Water Supplies Department

檔號
Reference (4) in WSD 3321/17 Pt.1 T/J(1464)

Approval of "GROHE" Basin Mixer

Model: 23161000

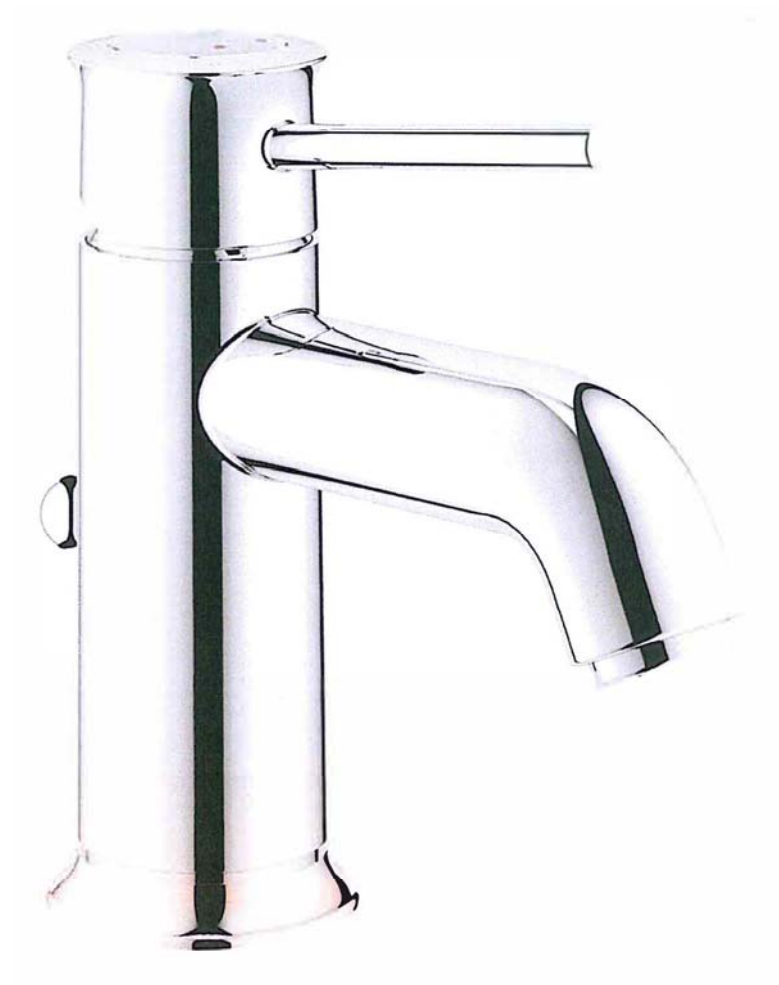
Details of Fitting: 3/8" Single lever basin mixer supplied with one pair of stainless steel wire braided water inlet flexible hose (manufactured by Neoperl GmbH. Model: Neoflex SPX DN6 G3/8") approved by UK's WRAS under ref. 1506306

"The cold water supply to the fitting shall be drawn from the same source that supplies the hot water apparatus so as to provide a balanced pressure and to obviate the risk of scalding in the event of a restriction or failure in the water supply."

A condition of this acceptance is that the fitting to be installed shall be replicas of the sample as certified by the testing agent mentioned above and without modifications. This acceptance may be withdrawn at any time if the standard of the fitting installed fails to meet that of the approved sample or if the fitting is found to be unsuitable for use in fresh water plumbing systems.
